HUNTINGTON PLACE COMMERCIAL

COMMUNITY UNIT PLAN

DP-153

RE: CUP2016-18 - City Community Unit Plan (DP-153) administrative adjustment to create Parcels 2A and 2B from Parcel 2 consistent with a lot split, south west of Maize Road and Maize Ct.

HUNTINGTON PLACE COMMERCIAL COMMUNITY UNIT PLAN

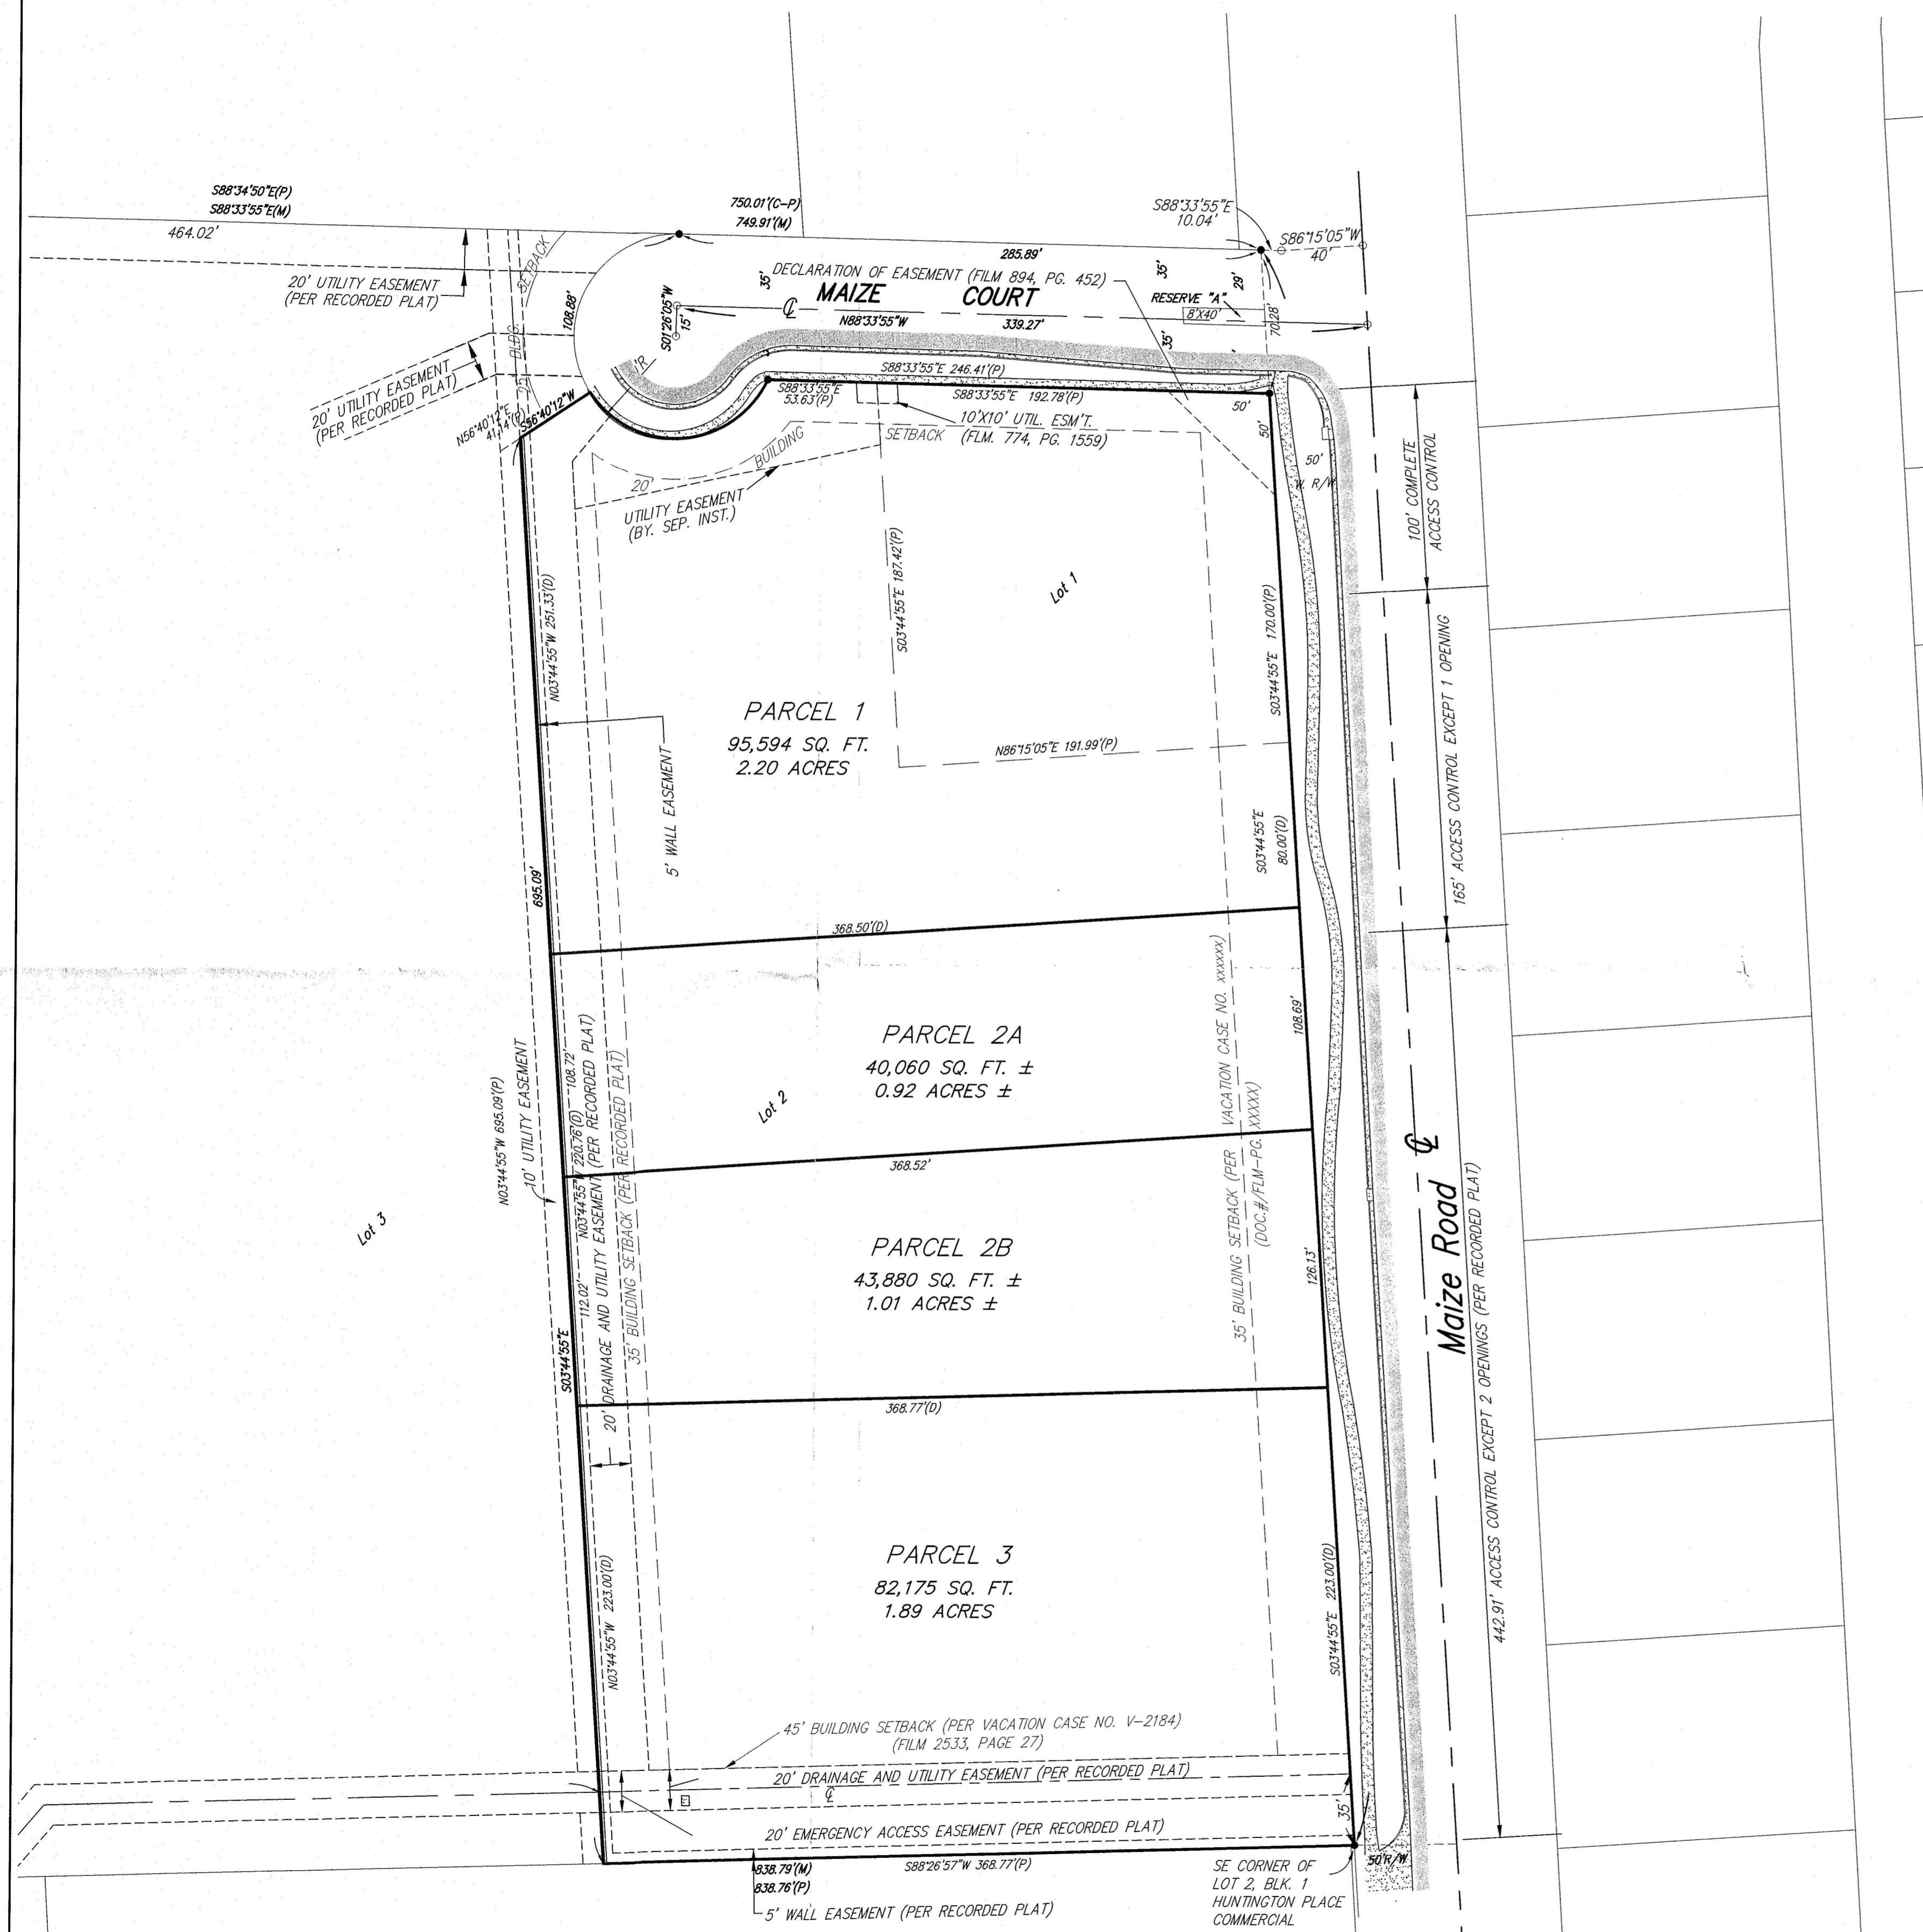
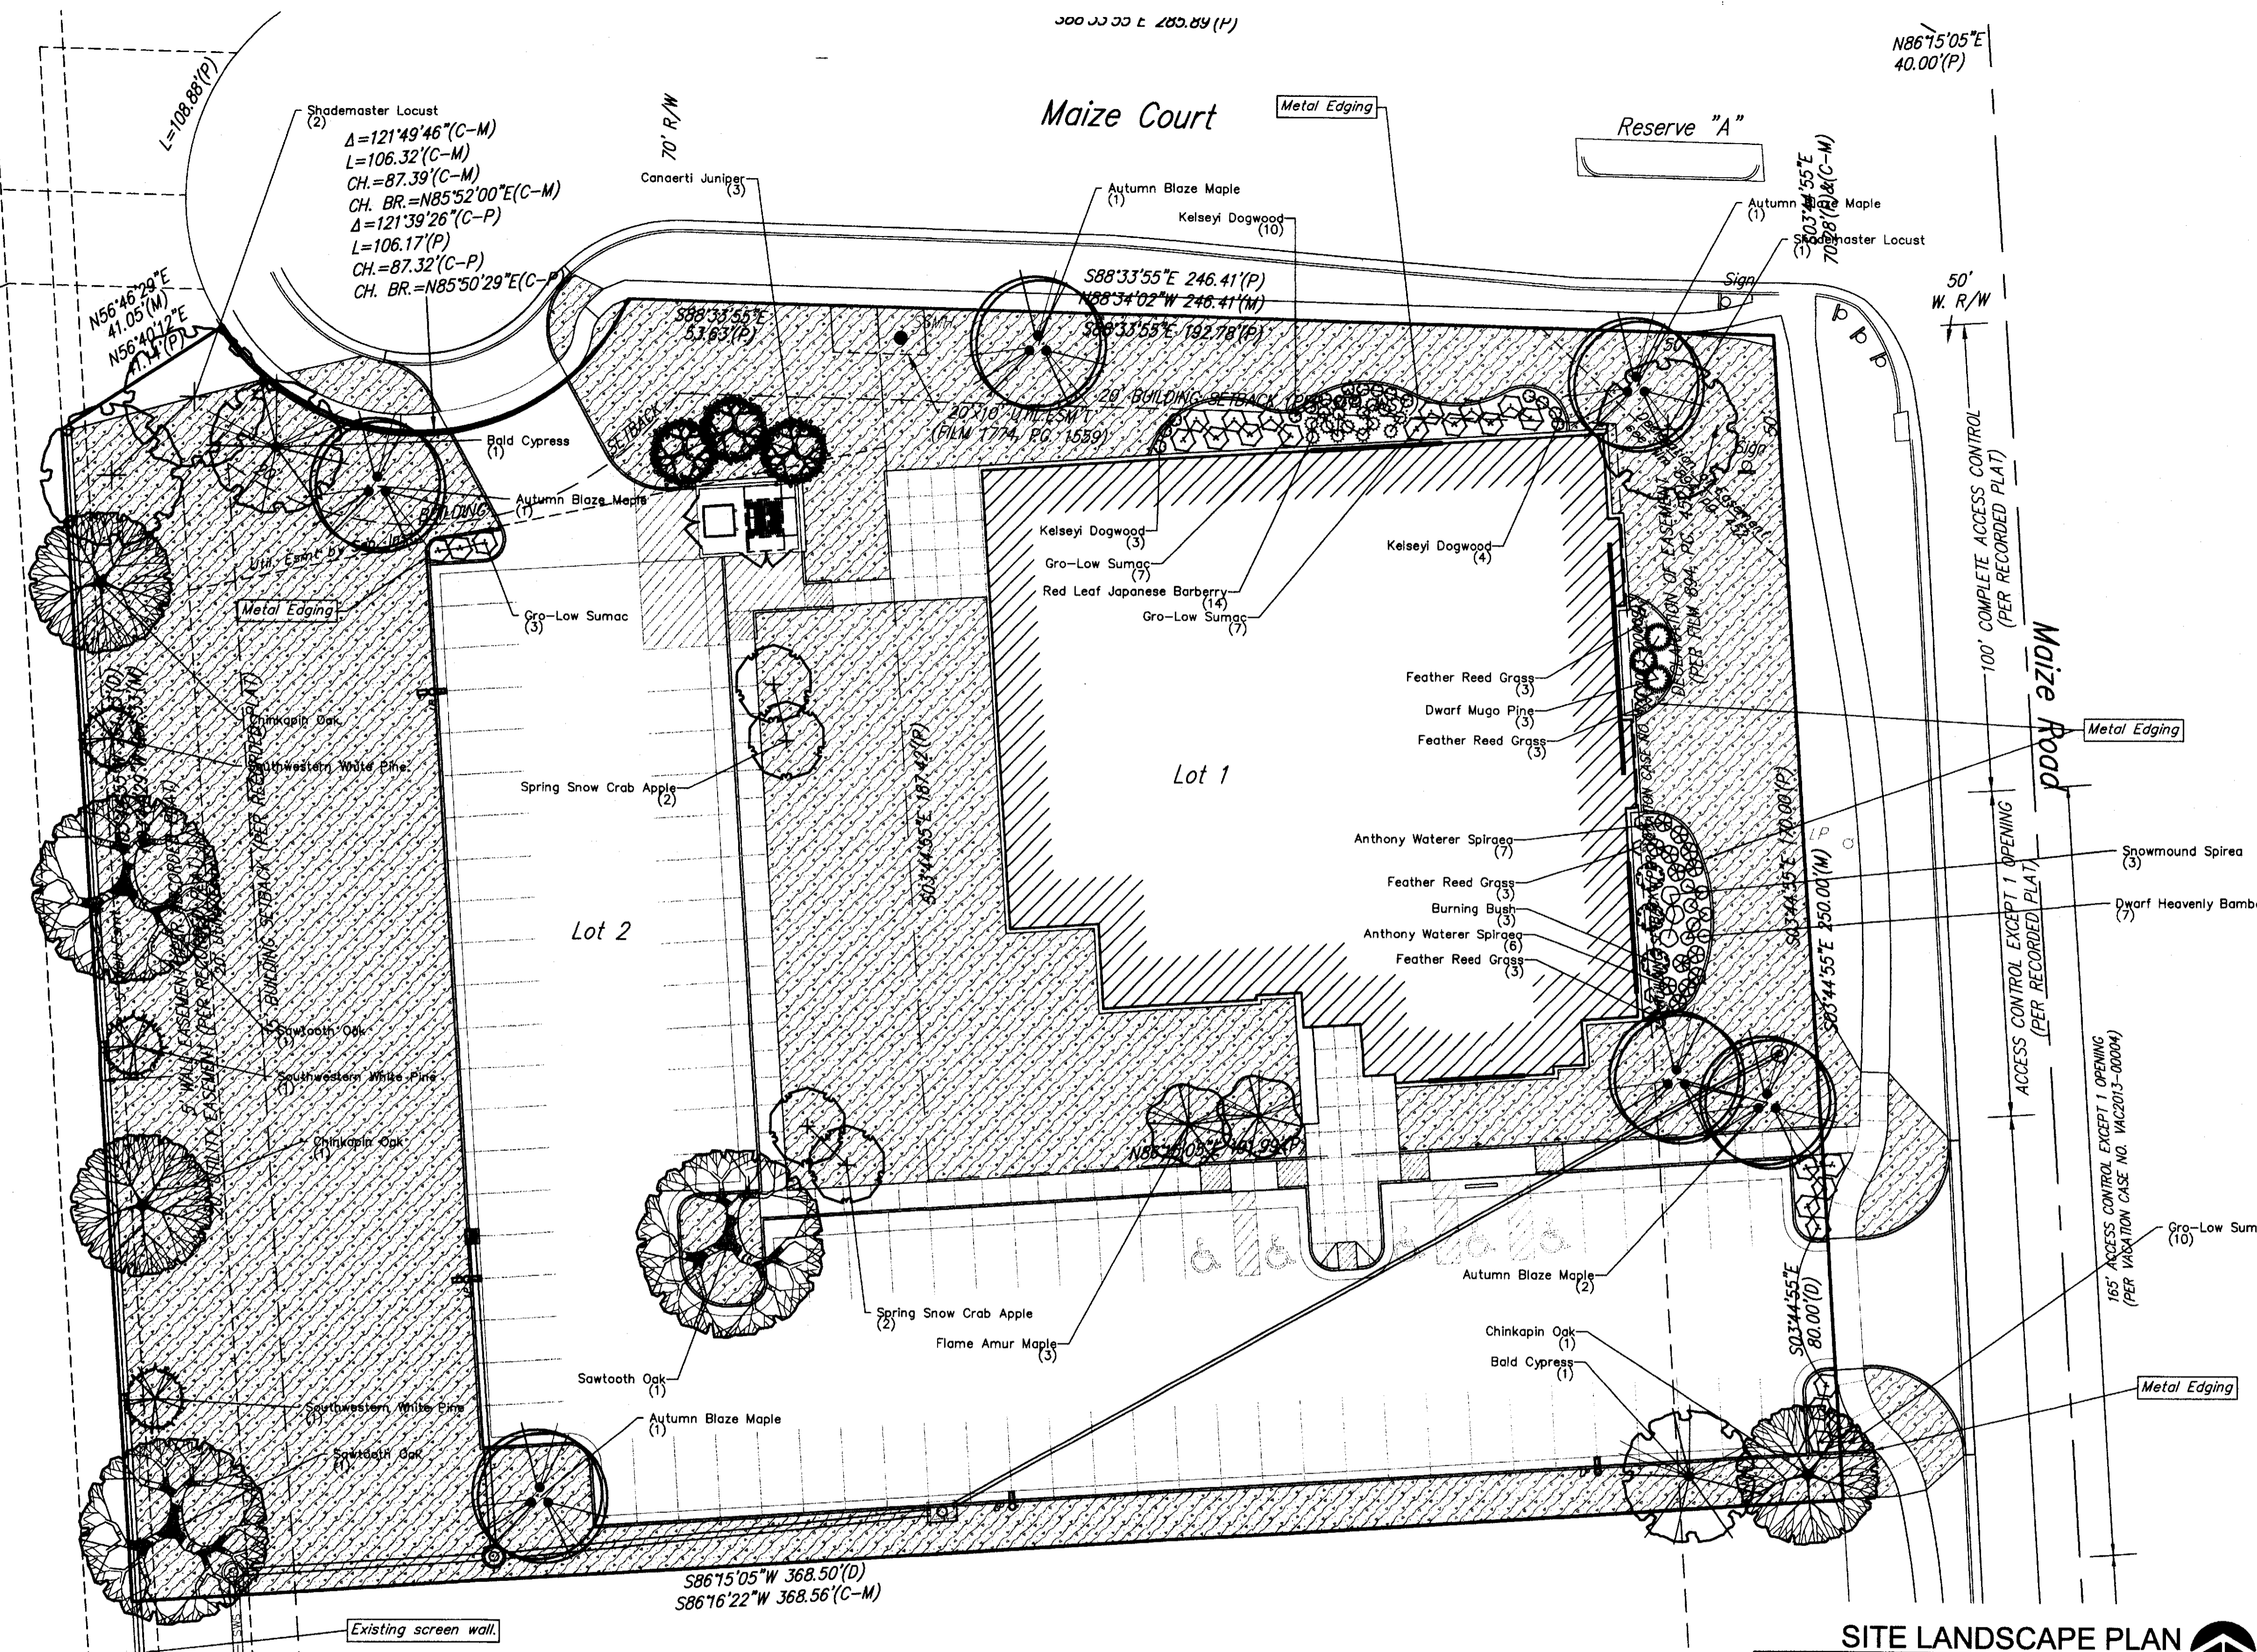
- (B) AS THE FRONTAGE DEVELOPS ALONG THE ARTERIAL ROADWAYS, MONUMENT TYPE SIGNS SHALL BE SPACED A MINIMUM OF 150 FEET APART, IRRESPECTIVE OF HOW LAND IS LEASED OR SOLD. SIGN SEPARATION BETWEEN PARCEL 1 AND PARCEL 2A MAY BE REDUCED TO 140 FEET PER ADMINISTRATIVE ADJUSTMENT DATED AUGUST 1, 2016 (CUP2016-29).

Approved: March 18, 1986
 Revised per Administrative Adjustment: May 31, 2001
 Revised per Administrative Adjustment: May 8, 2013
 Revised per Administrative Adjustment: June 18, 2013
 Revised per VAC2013-29: October 22, 2013
 Revised per Administrative Adjustment: May 3, 2016
 Revised per Administrative Adjustment: August 1, 2016

2A Site Plan
Scale - 1" = 50'-0"

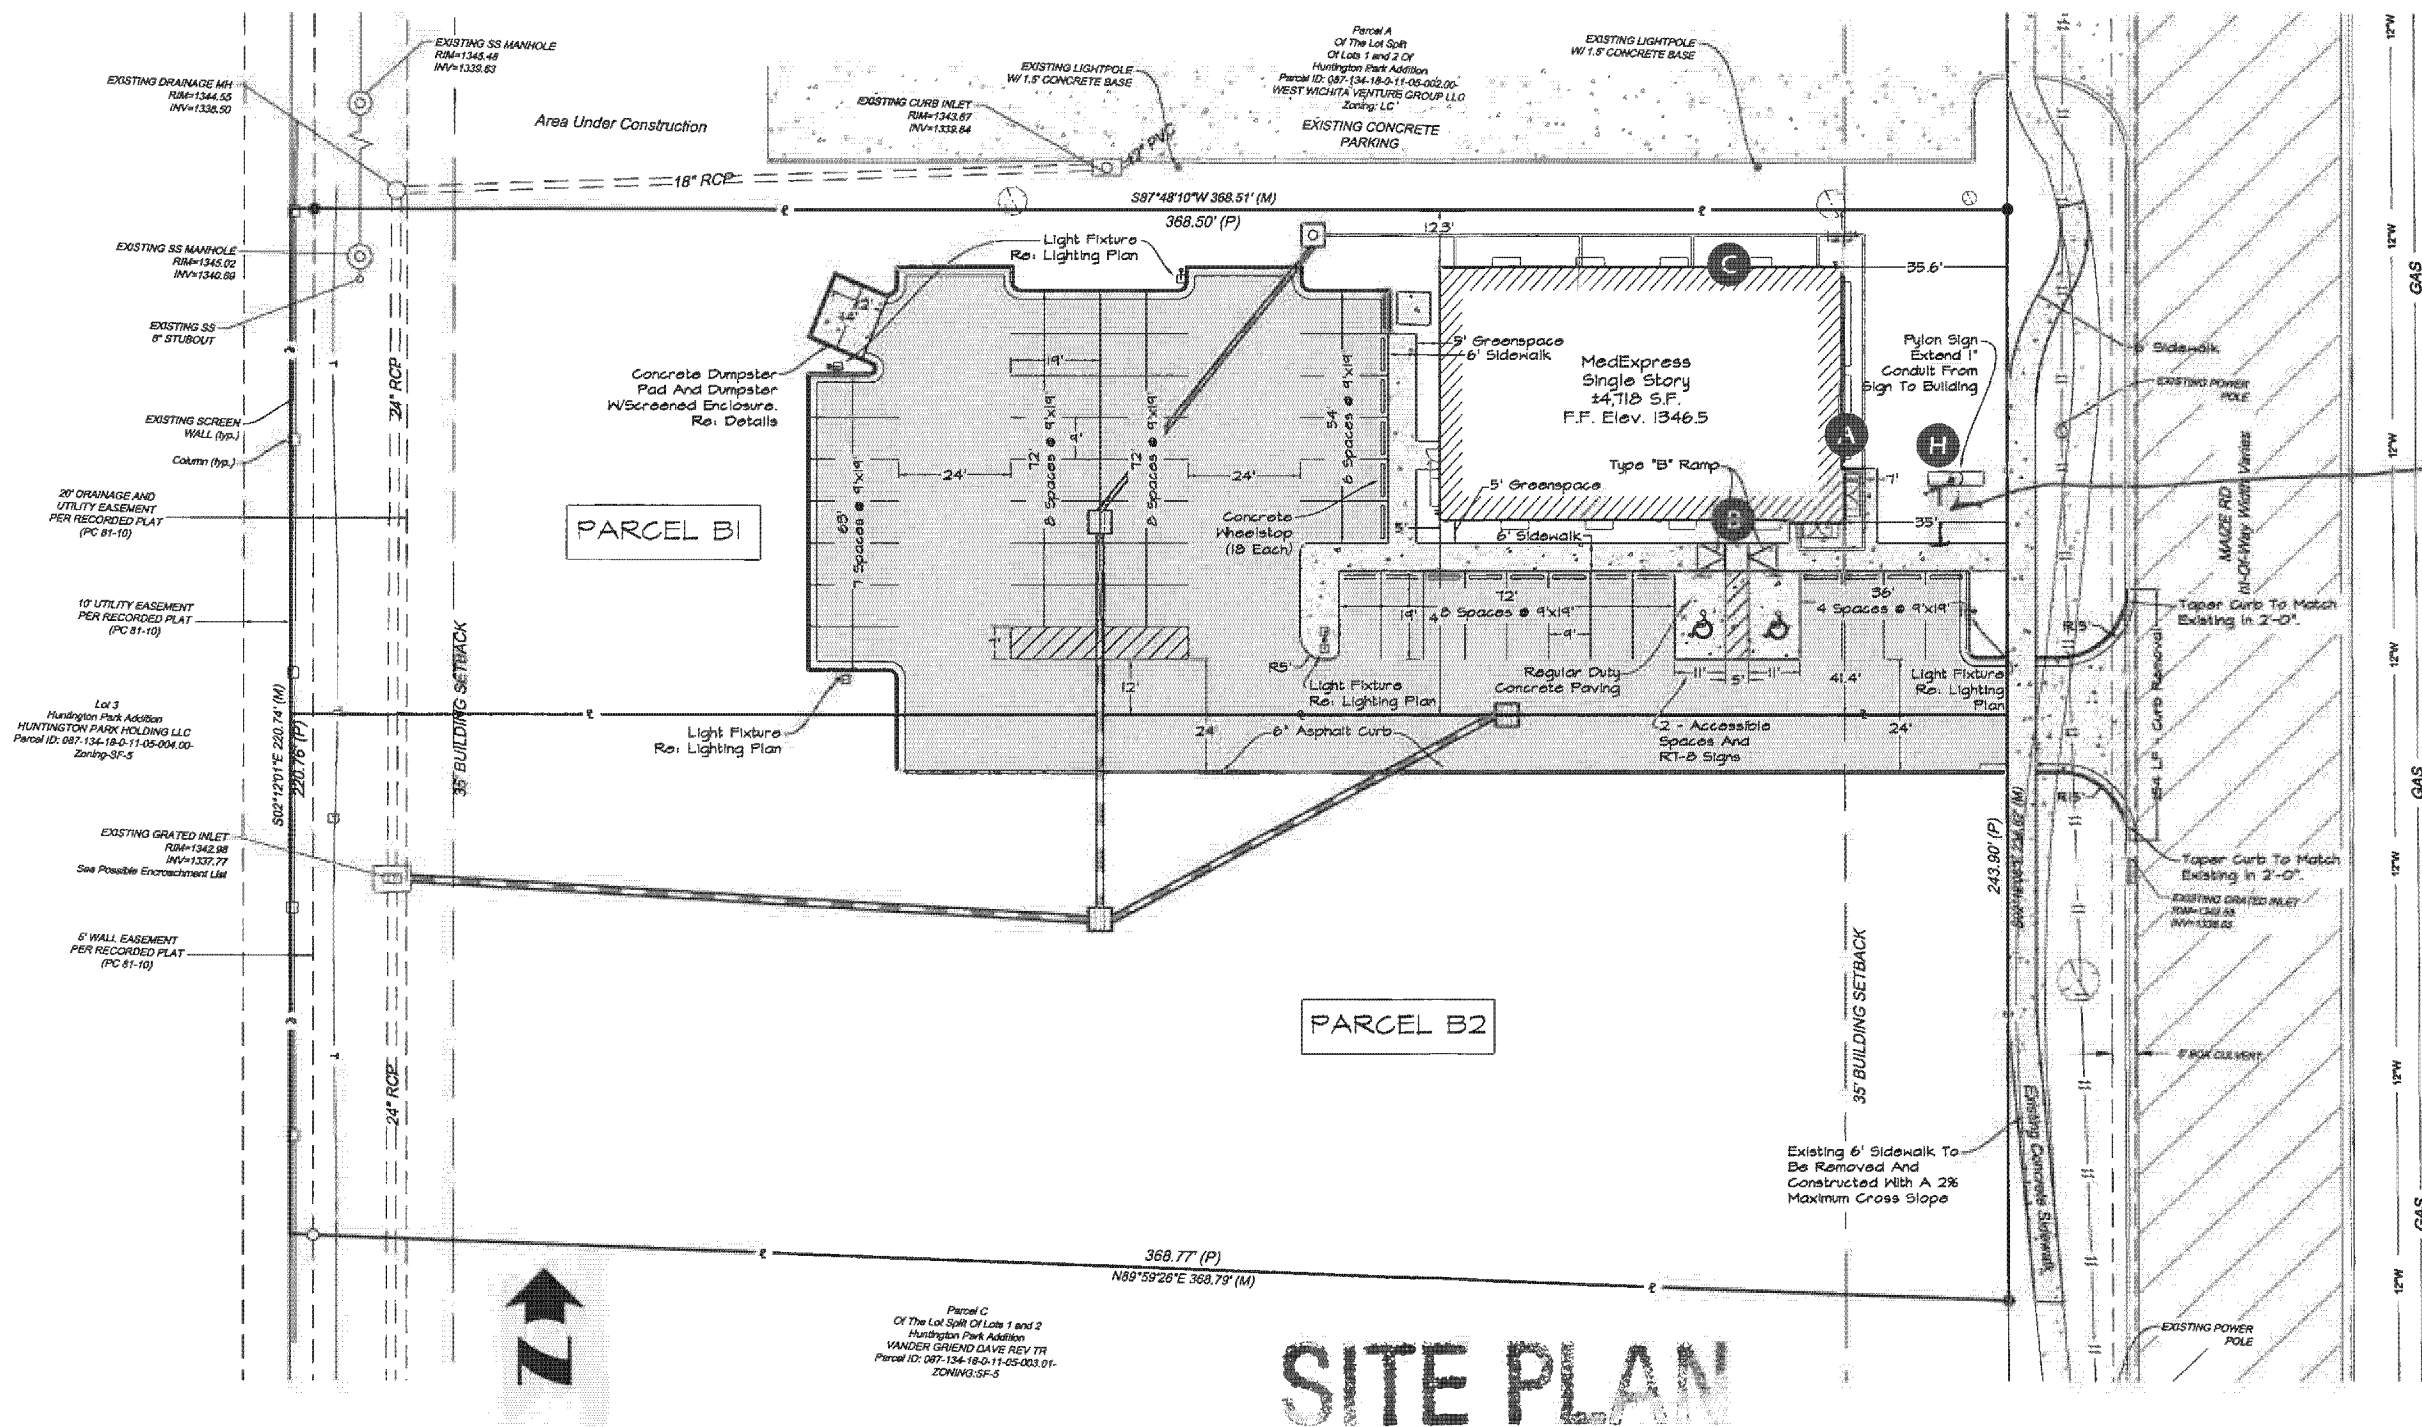
RE: CUP2016-29 – City CUP Administrative Adjustment to General Provision 5B of the Huntington Place Commercial CUP DP-153; generally located on the west side of Maize Road and south of W. 13th Street North (1261 N. Maize Rd.)

We received and reviewed your request for an Administrative Adjustment to DP-153, the Huntington Place Commercial Community Unit Plan (“CUP”). We understand that you wish to reduce the separation between signs from 150 feet to 140 feet to accommodate a new sign at the MedExpress Urgent Express building on N. Maize Road and the existing sign for Green Vision Group located to the north at 1277 N. Maize Road.

1. All signs shall be permitted and installed within one year.
2. The Administrative Adjustment applies only to the sign located on Lot 2, Huntington Park Addition (1261 N. Maize Road)
